SUBJECT: Grand Gulf Nuclear Station
Unit 1
Docket No. 50-416
License No. NPF-29
Request for Enforcement
Discretion to Implement
Organization Changes
AECM-88/0145

Additional Information Regarding The Formation of
The Performance and System Engineering Department

FIGURE 1

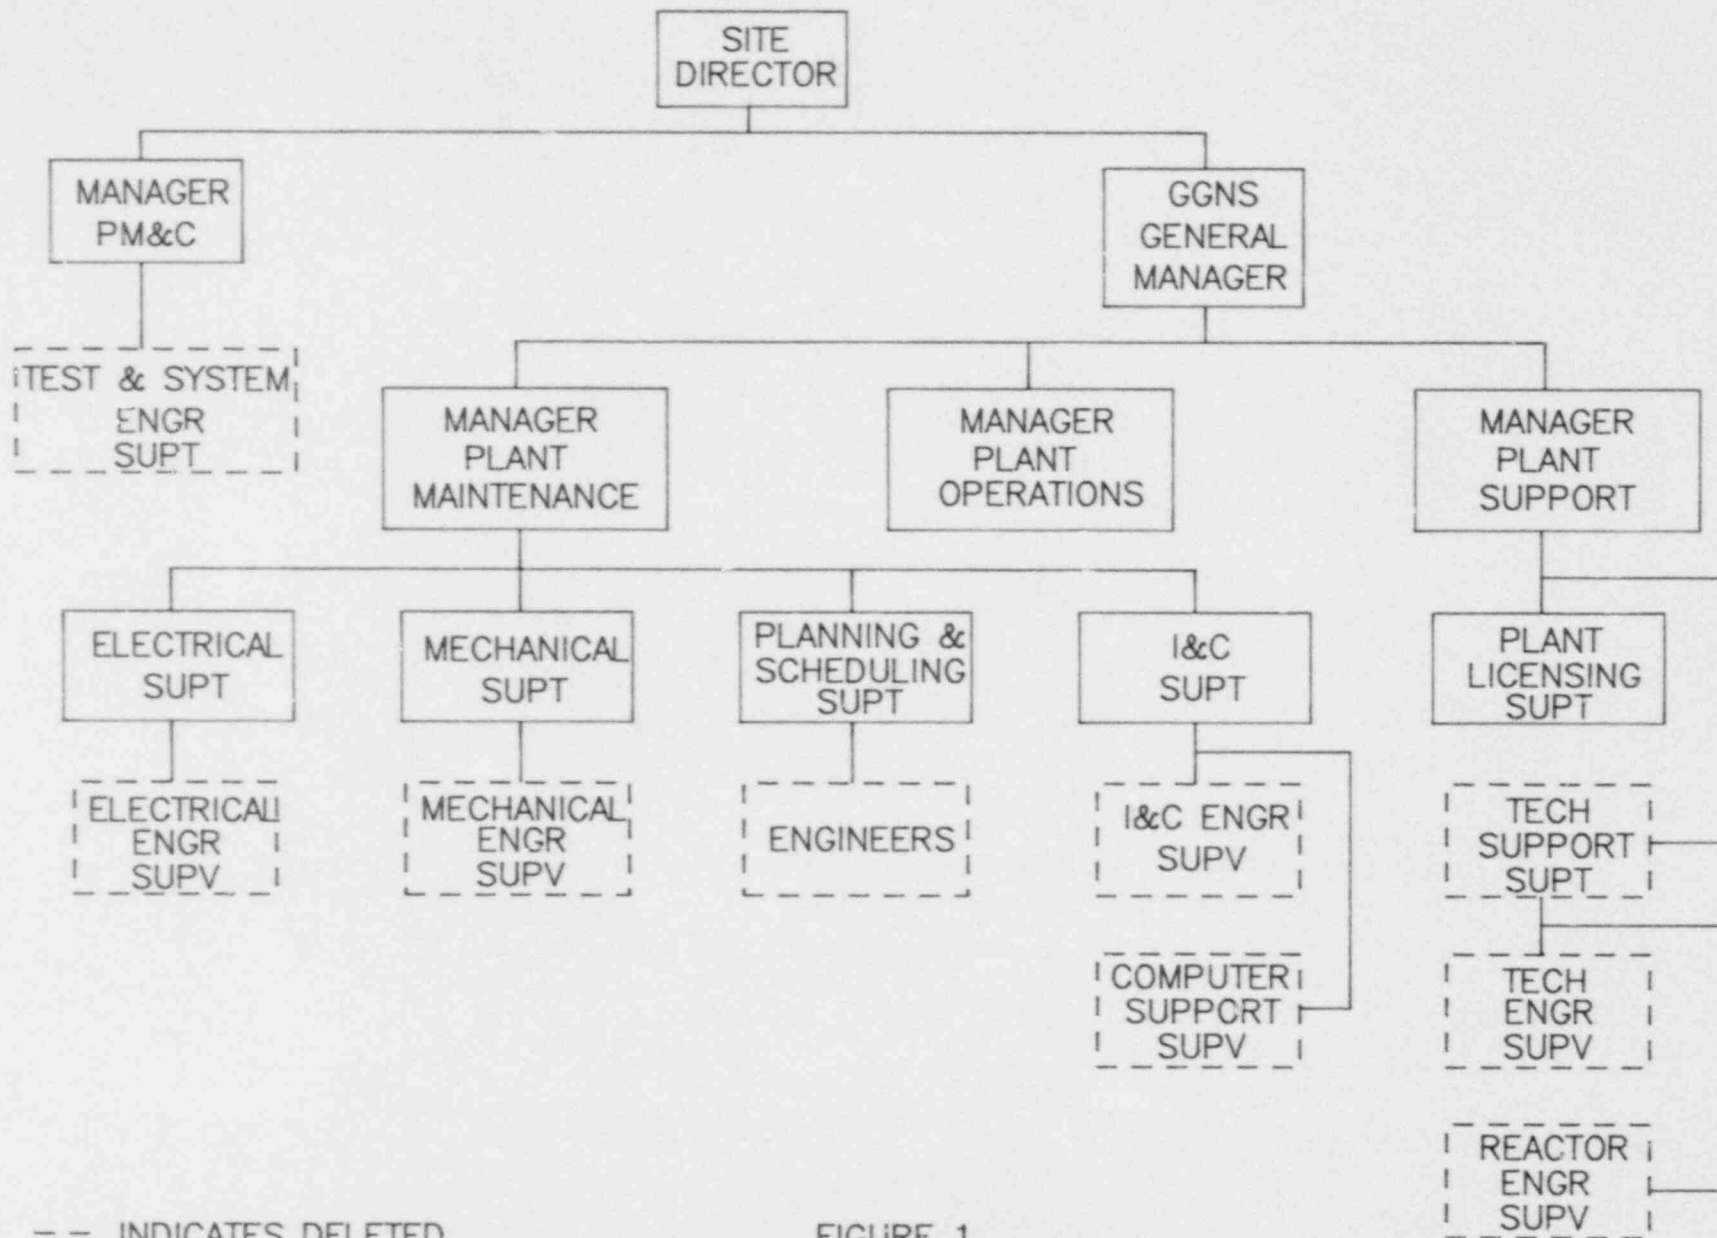
Presently, the engineering expertise of the plant staff organization resides in four distinct sections: Technical Engineering, Reactor Engineering, Plant Modification and Construction (PM&C), and Maintenance Engineering (I&C, Mechanical and Electrical, Planning & Scheduling) as shown in Figure 1. With this separation of the plant engineering expertise a clear division of responsibility does not exist. This contributes to some degree of confusion and misunderstanding, which in turn detracts from SERI's full capability to effectively and efficiently resolve plant problems.

As a part of the organizational realignment, the Technical Support Superintendent position is being deleted. The Technical Support Superintendent is currently a member of the Plant Safety Review Committee (PSRC) as indicated in Technical Specification (TS) 6.5.1.2. Therefore, with this position being deleted the following administrative change is needed to TS 6.5.1.2: replace the Technical Support Superintendent with the Manager, P&SE.

FIGURE 2

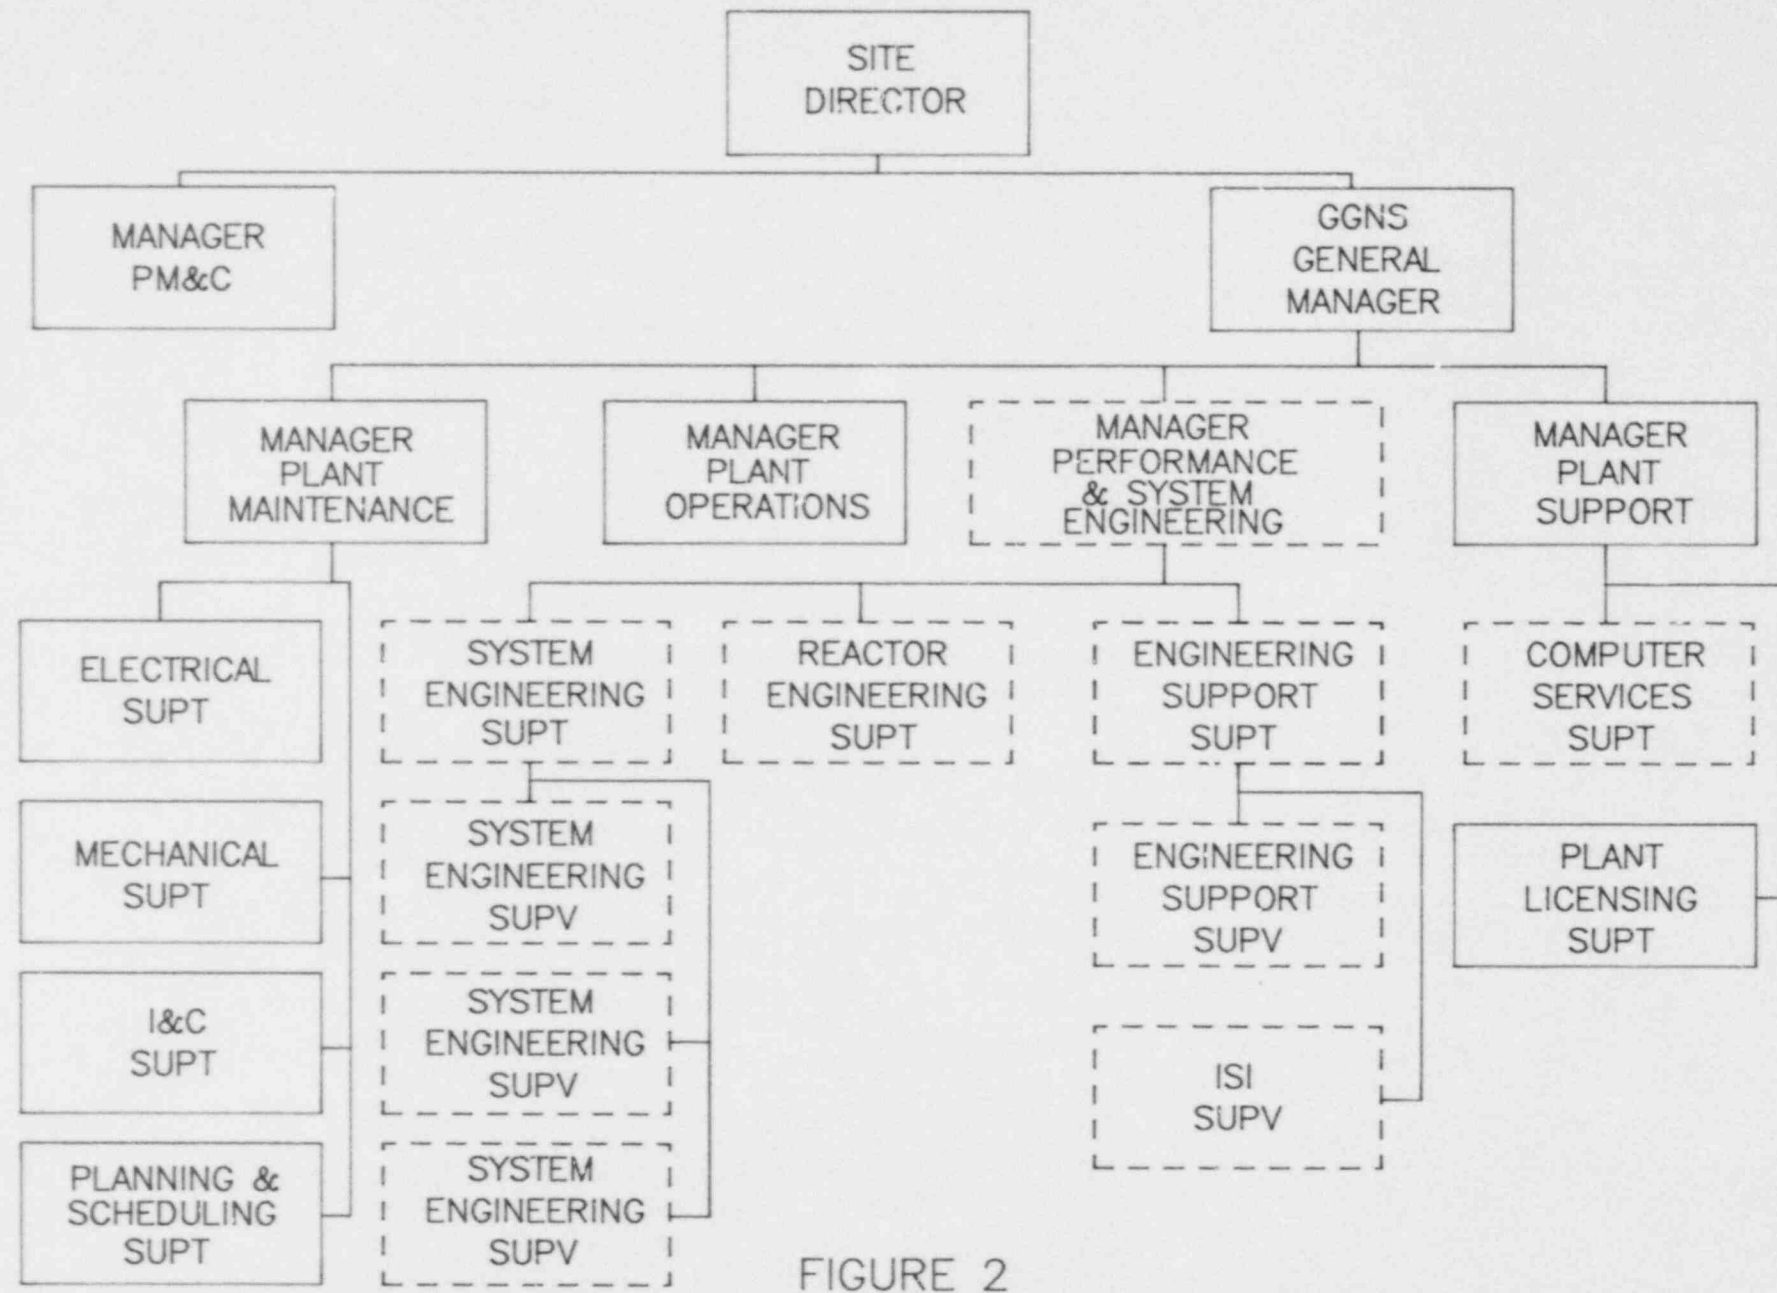
Plant staff engineering is being consolidated into the Performance and System Engineering (P&SE) Department under a new position, the Manager P&SE. P&SE will be formed by consolidating various engineering staffs - those in Technical Engineering, Reactor Engineering, PM&C, and Maintenance Engineering. P&SE will serve as a single source of engineering expertise on plant systems. This strengthened organization will enhance the operation of Grand Gulf Nuclear Station (GGNS) by providing a focused management approach to plant engineering functions. By consolidating the plant engineering expertise, duplication of engineering tasks within the various organizations will be essentially eliminated. Consolidating resources will mean a more effective use of engineering capabilities on site.

The Manager, P&SE will be responsible for activities necessary to support the operations of GGNS, Unit 1. This includes System Engineering management, Inservice Inspection Program management, Reactor Engineering management and the engineering support of maintenance and operations. The Manager, P&SE will report to the GGNS General Manager and will be assisted by the System Engineering Superintendent, the Reactor Engineering Superintendent and the Engineering Support Superintendent.

The System Engineering Superintendent will be responsible for plant staff system engineering functions. The system engineering function will provide system engineers who have overall system and component expertise on their assigned systems. He will be responsible for technical activities associated with design changes, the collection, collating and evaluation of data, reliability analysis and root cause analysis. The System Engineering Superintendent will have three System Engineering Supervisors under his direction and will report to the Manager, P&SE.

The Engineering Support Superintendent will provide administrative support to the Manager, P&SE. He will also be responsible for those portions of programs such as Inservice Inspection, Thermal Performance Monitoring and Equipment Qualification assigned to the plant staff. The Engineering Support Superintendent will have two supervisors, the Inservice Inspection Supervisor and Engineering Support Supervisor, under his direction and will report to the Manager, P&SE.

The Reactor Engineering Superintendent will be responsible for onsite core management and periodic reactor testing, in-plant nuclear materials control and accountability, and providing assistance to reactor operators during control rod pattern adjustments. The Reactor Engineering Superintendent will report to the Manager, P&SE.
